M9502A-03

S E R V I C E N O T E

M9502A AXIe 2 slot Chassis

Incorrect LAN LEDs labeling on the Embedded System Module (ESM) front panel

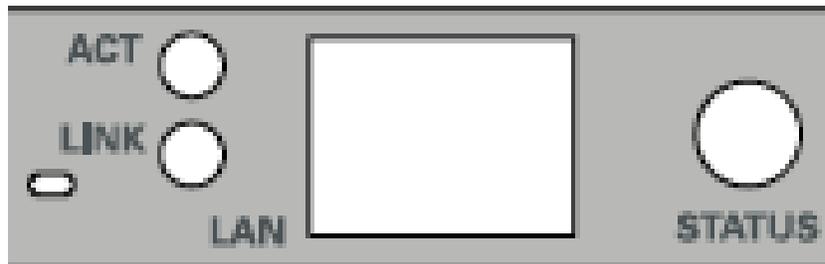
Incorrect LAN LEDs labeling on the ESM front panel showing the wrong label for the speed, link and activity (LINK/ACT) LEDs.

Incorrect label shows:

Correct label shows:

Please contact your local Agilent service center to send in your M9502A AXIe chassis and ESM for replacement of the ESM front panel label. Or you can order the label “M9505-39130” from Agilent and replace it yourself. Please follow the instructions below on how to replace the ESM front panel label.

1. Power off the chassis and remove the ESM from the chassis.
2. Hold the ESM in place and peel the incorrect label off the ESM front panel.
3. Use Isopropyl Alcohol to clean any excess glue left over on the ESM front panel before applying the correct label.
4. Apply the correct label (M9505-39130) onto the ESM front panel. Align the label to the left edge and bottom of the panel to apply on the front panel.
